**Descriptive Report to Accompany
Hydrographic Survey H11614
Scale 1:20,000, Surveyed 2007
M/V Thomas R. Dowell and F/V Lacey Marie
Science Applications International Corporation (SAIC)
Paul L. Donaldson, Lead Hydrographer**

PROJECT**Project Number:** S-J977-KR-SAIC**Dates of Instructions:** October 18, 2006**Task Order#:** T0002**Dates of Supplemental Instructions:** 25 October 2006, 16 November 2006, 09 January 2007, 30 May 2007, and 03 October 2007**Sheet Letter:** C**Registry Number:** H11614**Purpose:** To provide NOAA with accurate hydrographic survey data suitable for item detection and debris mapping in the assigned area: Sheet C (H11614) in Lake Borgne, Louisiana.**A. AREA SURVEYED**

Figure D-1. Proposed Foul Area Bounds by Fort Beauregard (Blue Polygon)

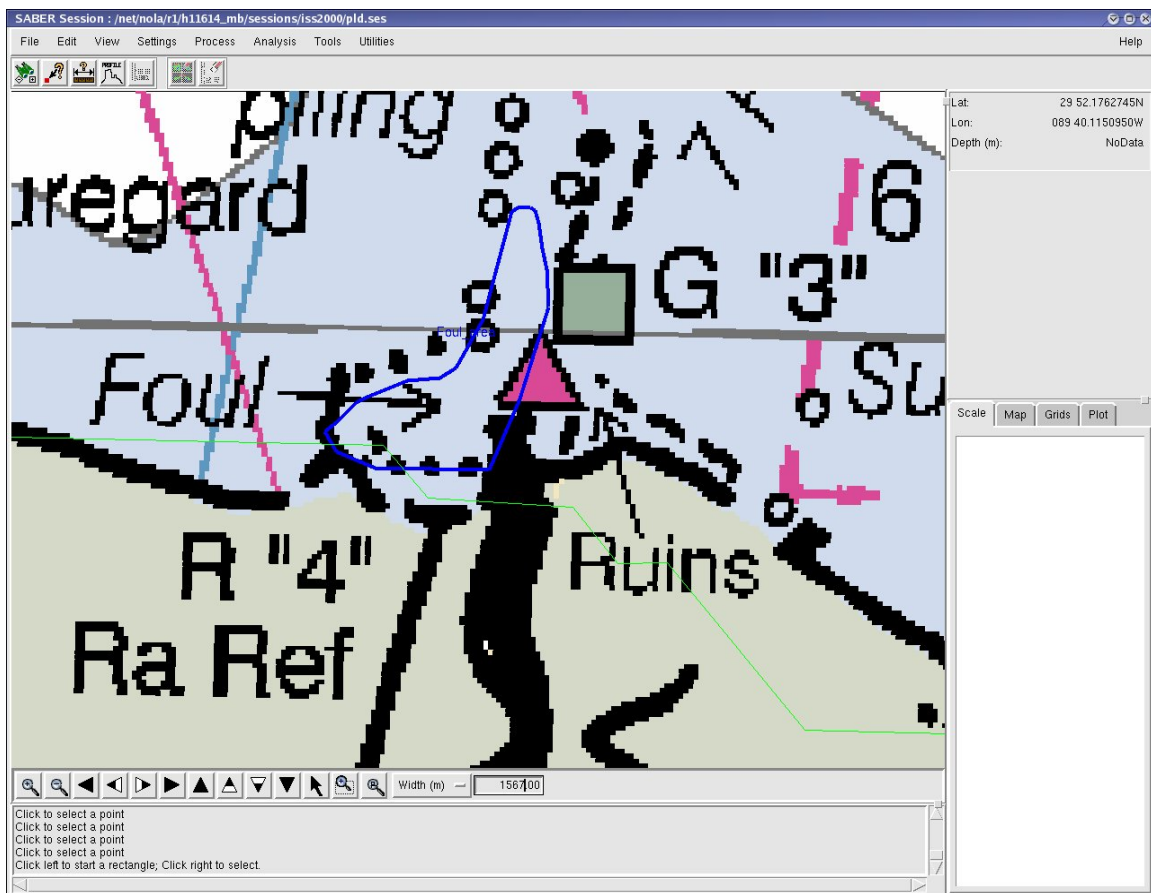
The charted submerged piles extending from 29° 52' 22.70"N 089° 40' 31.47"W to 29° 52' 10.52"N 089° 40' 32.95"W were not found as charted. Submerged piles were found extending from 29° 52' 07.18"N 089° 40' 30.78"W (contact 071164300, no feature made) to 29° 52' 12.10"N 089° 40' 29.11"W (feature 25). While two contacts were made to identify the bounds of piles (contacts 071164300 and 071155035) most of the

piles within this area had no significant height (20cm to 30cm). There were also several piles laying flat on the bottom (contact 071155044) in 29° 52' 12.38"N 089° 40' 30.39"W. Additional debris was found approximately 50 meters to the southeast of the charted pile in 29° 52' 17.43"N 089° 40' 32.40"W, however the debris had no significant height. Debris was also found in the area just offshore of Fort Beauregard in 29° 52' 04.69"N 089° 40' 39.51"W (feature 13). Recommend removing the 6 charted pile symbols in 29° 52' 22.70"N 089° 40' 31.47"W to 29° 52' 10.52"N 089° 40' 32.95"W and charting pile symbols in 29° 52' 07.18"N 089° 40' 30.78"W (contact 071164300) and 29° 52' 12.10"N 089° 40' 29.11"W (feature 25) and changing the label Subm piling to Subm Piles. Recommend extending the currently charted Foul area northward to 29° 52' 17.49"N 089° 40' 30.13"W to encompass the debris with no significant height near the charted pile in 29° 52' 17.43"N 089° 40' 32.40"W, the submerged piles in 29° 52' 12.10"N 089° 40' 29.11"W (feature 25) and 29° 52' 07.18"N 089° 40' 30.78"W (contact 071164300) (Figure D-1). Retain the label Foul and arrow as currently charted. ***Do not concur. Recommend to chart submerged pile in 29° 52' 07.18"N 089° 40' 30.78"W. Submerged pile in 29° 52' 12.10"N 089° 40' 29.11"W lies within the Foul area, hence do not recommend to chart.***

Figure D-2. Proposed Ruins Area East of Bayou Yscloskey (Blue Polygon)

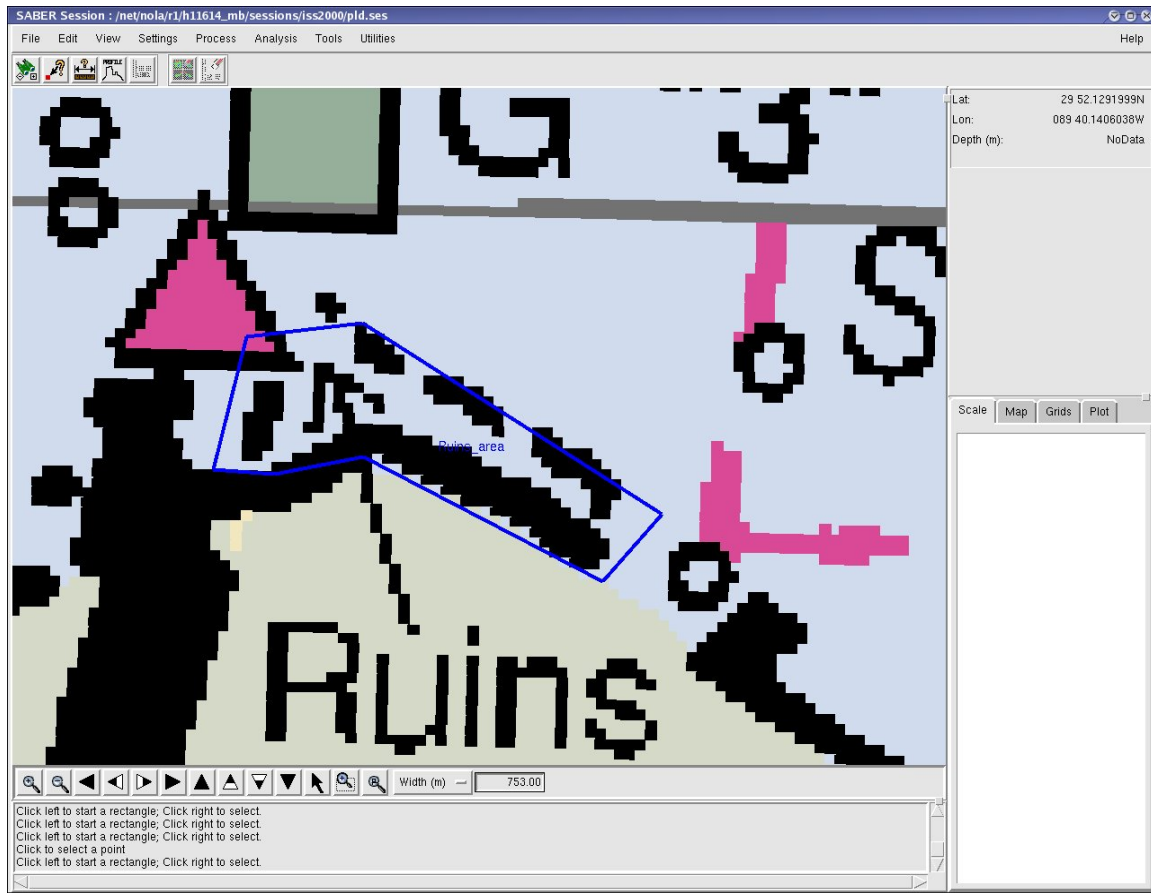
The charted Ruins area defined by a dashed line in 29° 52' 01.59"N 089° 40' 18.23"W, 29° 52' 03.81"N 089° 40' 16.63"W, 29° 52' 08.55"N 089° 40' 25.89"W and 29° 52' 03.85"N 089° 40' 28.25"W consisted of exposed piles and the remains of a naval installation. The charted area does not fully cover the extents of the ruins as determined by this survey. Recommend removing the currently charted ruins area defined by a dashed line in 29° 52' 01.59"N 089° 40' 18.23"W, 29° 52' 03.81"N 089° 40' 16.63"W, 29° 52' 08.55"N 089° 40' 25.89"W and 29° 52' 03.85"N 089° 40' 28.25"W and charting an area consisting of a dashed line in 29° 52' 01.21"N 089° 40' 17.11"W (feature 22), 29° 52' 03.23"N 089° 40' 15.54"W, 29° 52' 07.81"N 089° 40' 24.48"W (feature 08), 29° 52' 07.36"N 089° 40' 27.95"W (feature 09) and 29° 52' 03.89"N 089° 40' 29.06"W. Retain the label Ruins and arrow as charted (Figure D-2). **Concur.**

Feature #: 0001 Least Depth: 3 (ft), 1.12 (m) Lat: 29 52 23.90N Lon: 089 38 33.40W Ping: 9431 Beam: 510

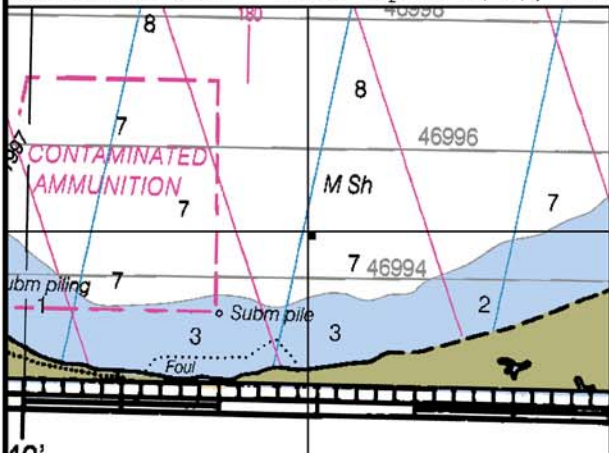
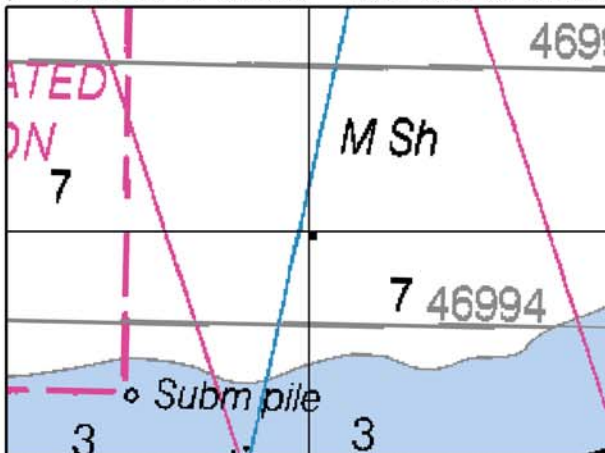
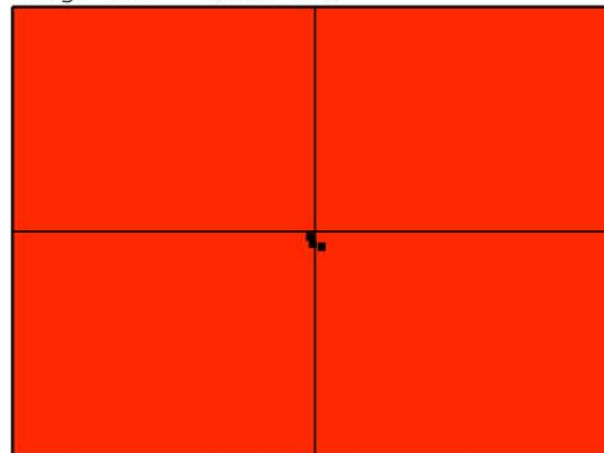
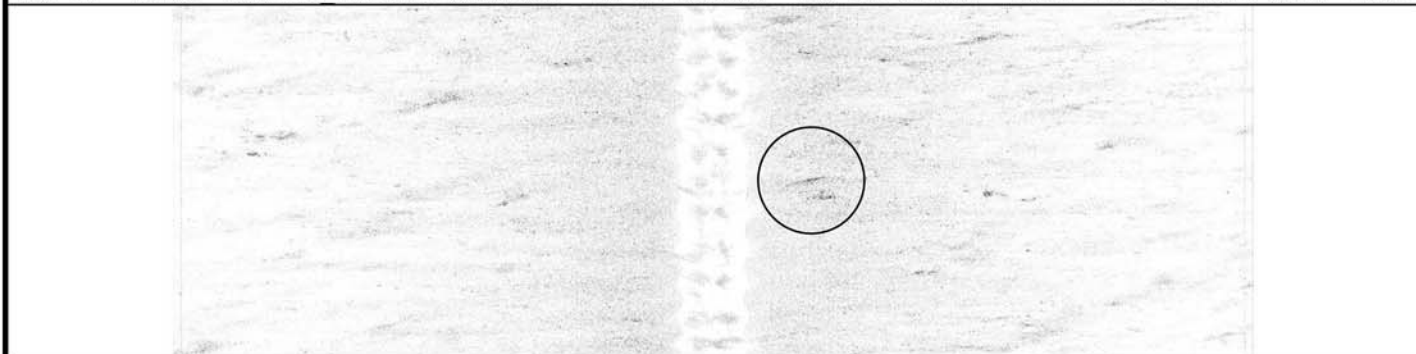
COMMENT:
OBSTR Plot sounding and label
Obstr.

Feature #: 0002 Least Depth: 4(ft), 1.25(m) Lat: 29 52 22.84N Lon: 089 39 08.67W Ping: 8865 Beam: 1221

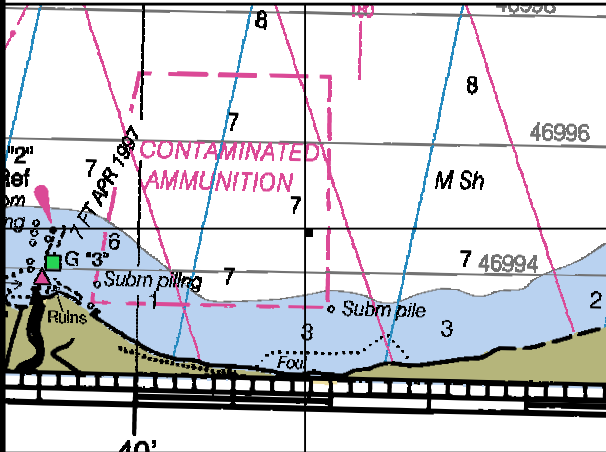
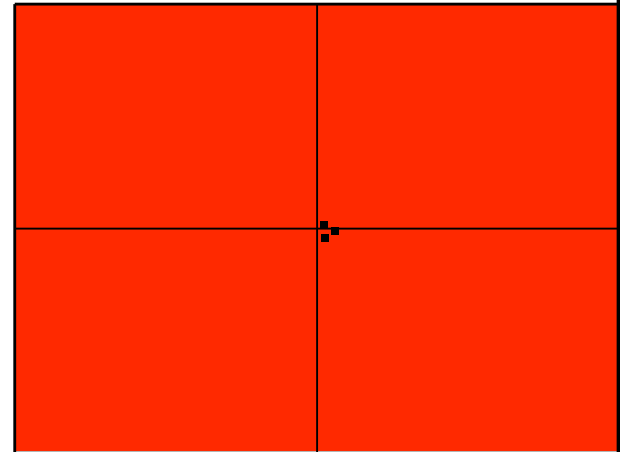
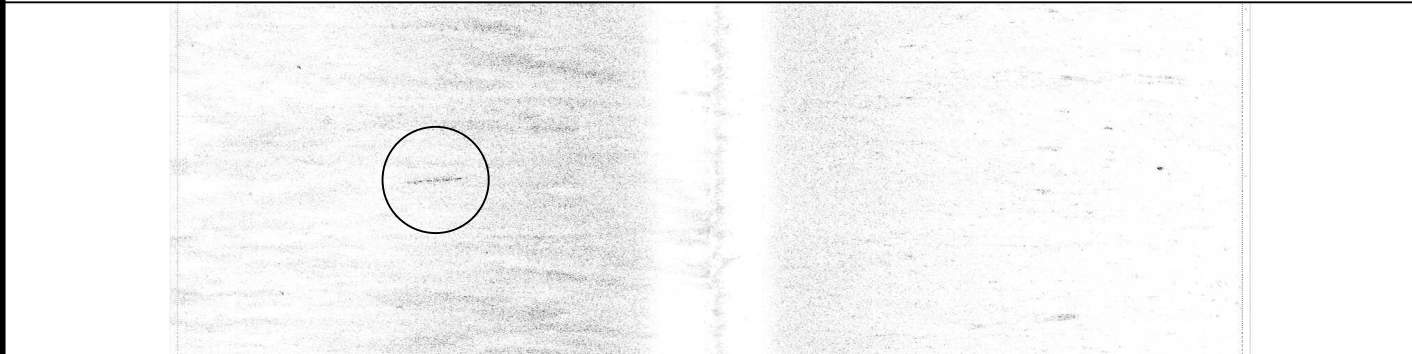
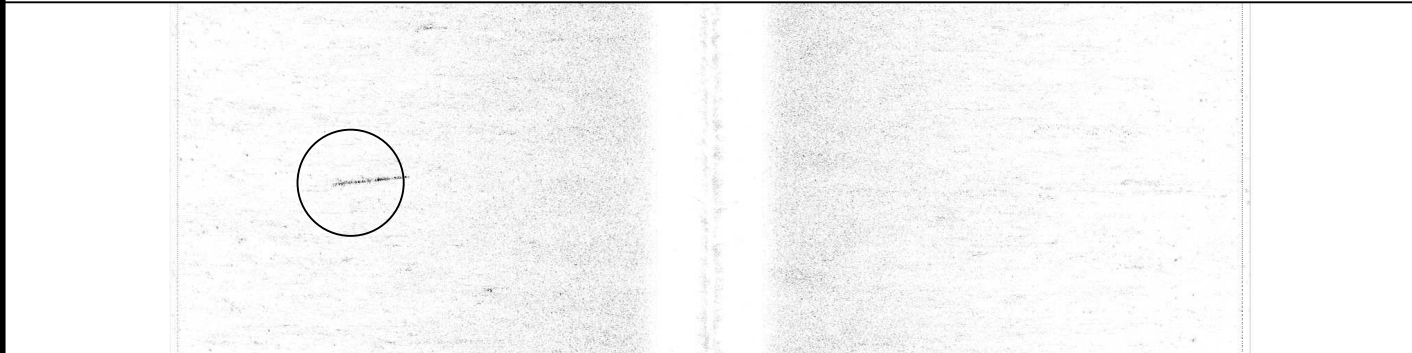
COMMENT:
OBSTR Plot sounding and label
Obstr.

Feature #: 0005 Least Depth: Lat: 29 52 20.41N Lon: 089 40 26.39W Ping: Beam:

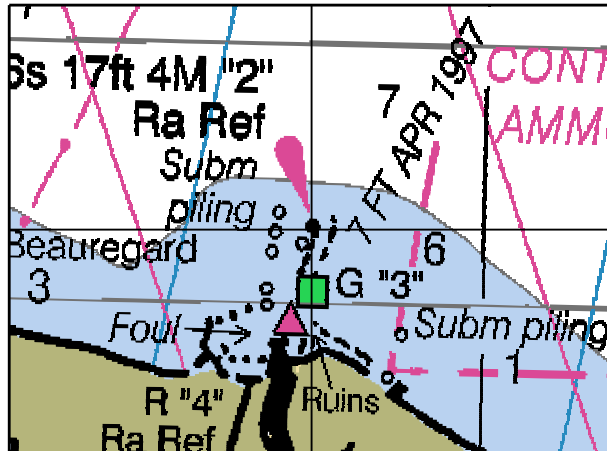
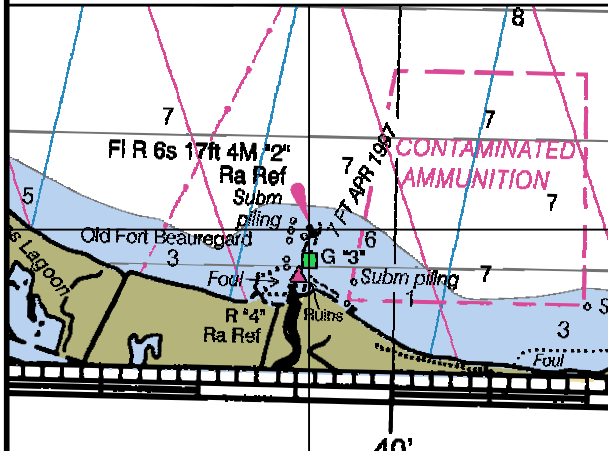
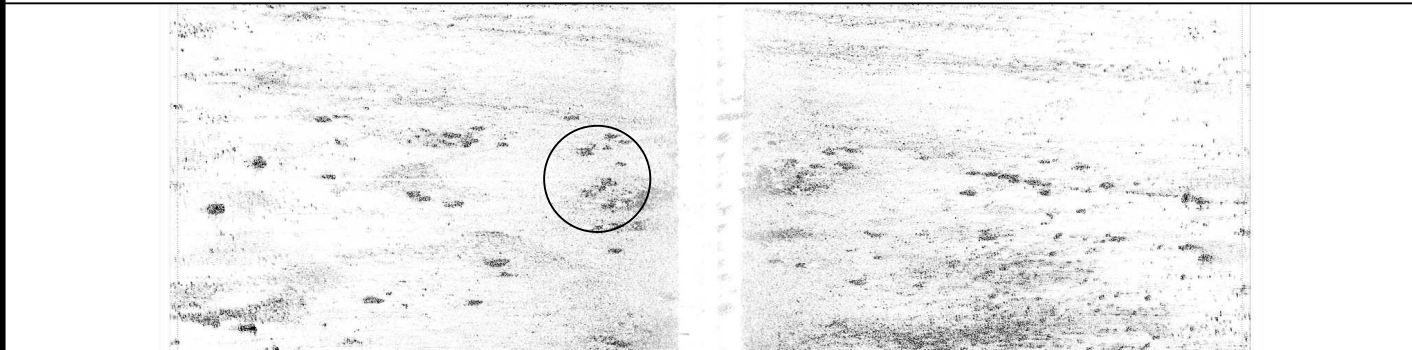
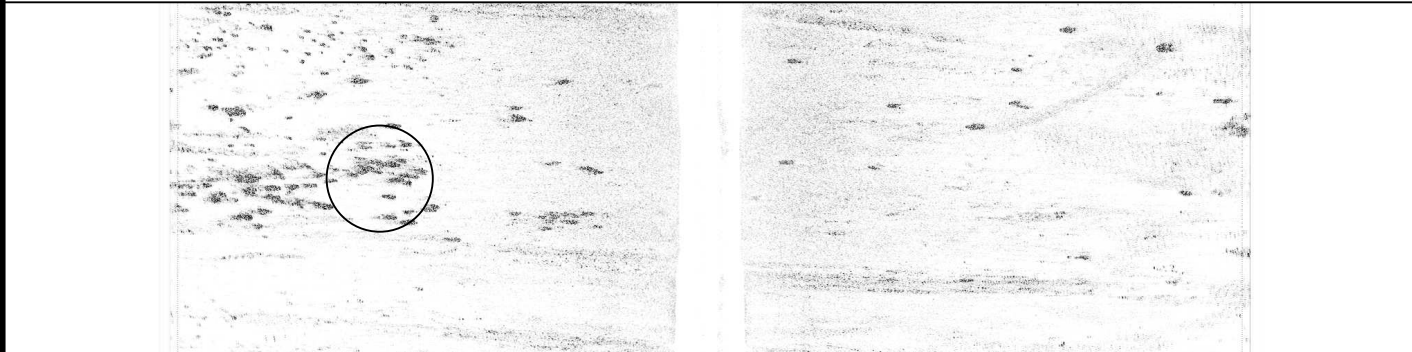
COMMENT:
 DAYBEACON Plot Daybeacon
 symbol and label Fl R 6s 17ft
 4M '2' Ra Ref.

Feature #: 0010 Least Depth: 4(ft), 1.35(m) Lat: 29 52 04.77N Lon: 089 40 12.71W Ping: Beam:

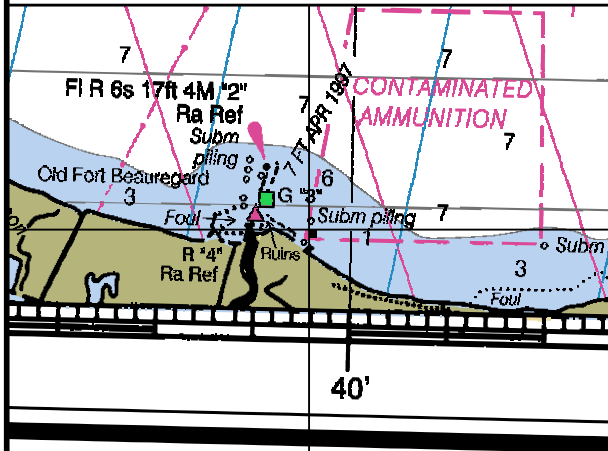
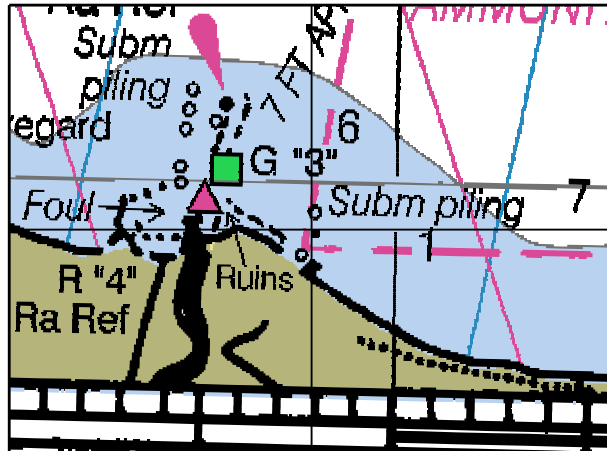
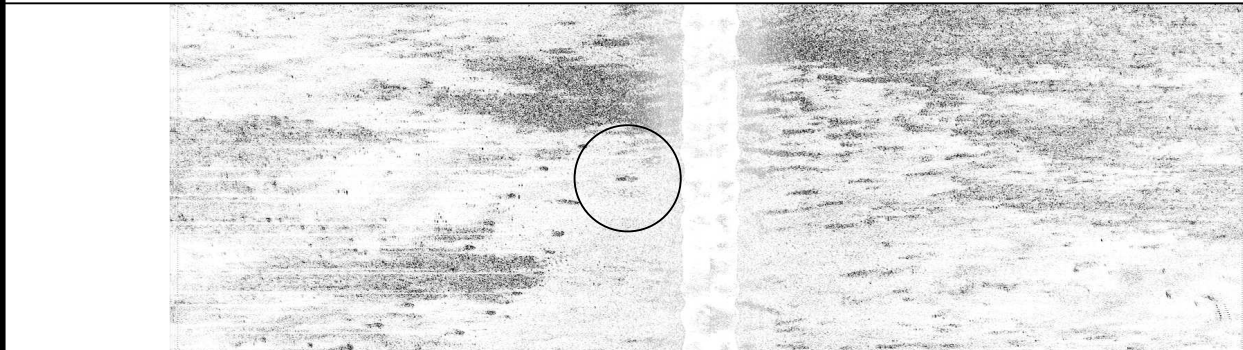
COMMENT:
SUBM PILE No Plot. See Features 11, 23 and 24 (least depth estimated from side scan).

Feature #: 0013 Least Depth: 5(ft), 1.57(m) Lat: 29 52 04.69N Lon: 089 40 39.51W Ping: Beam:

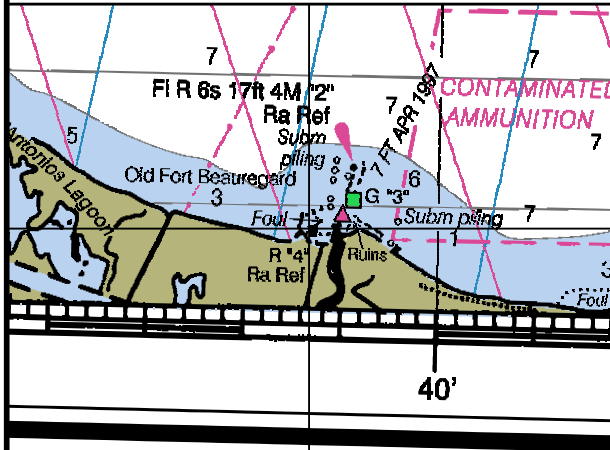
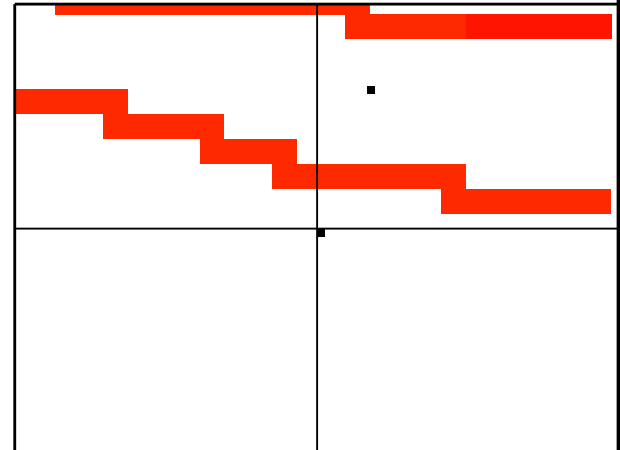
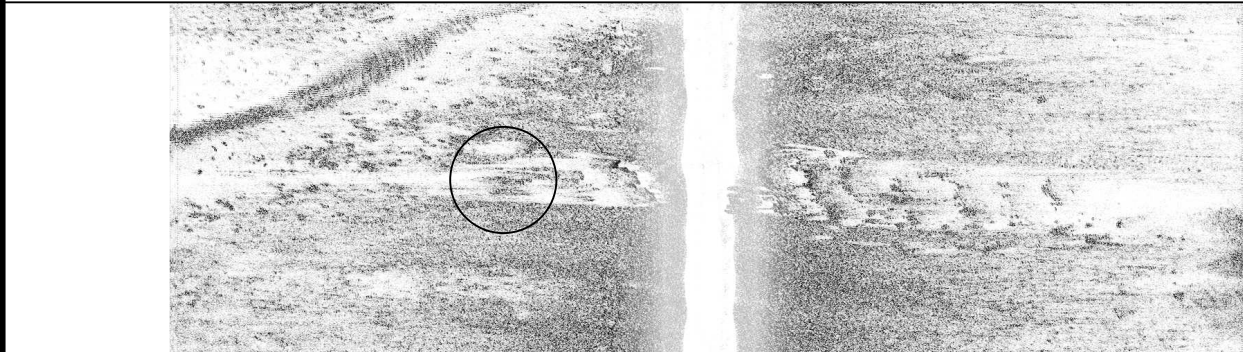
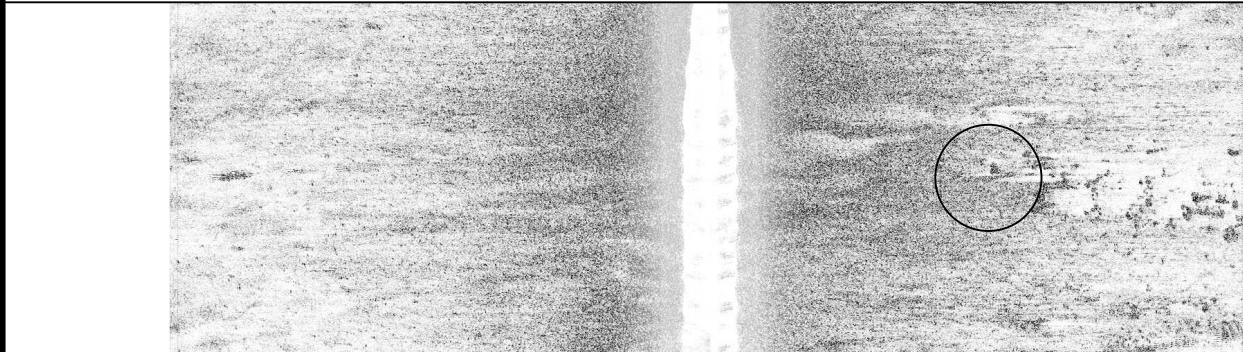
COMMENT:
OBSTRS Plot sounding and symbol Obstrs (least depth estimated from side scan).
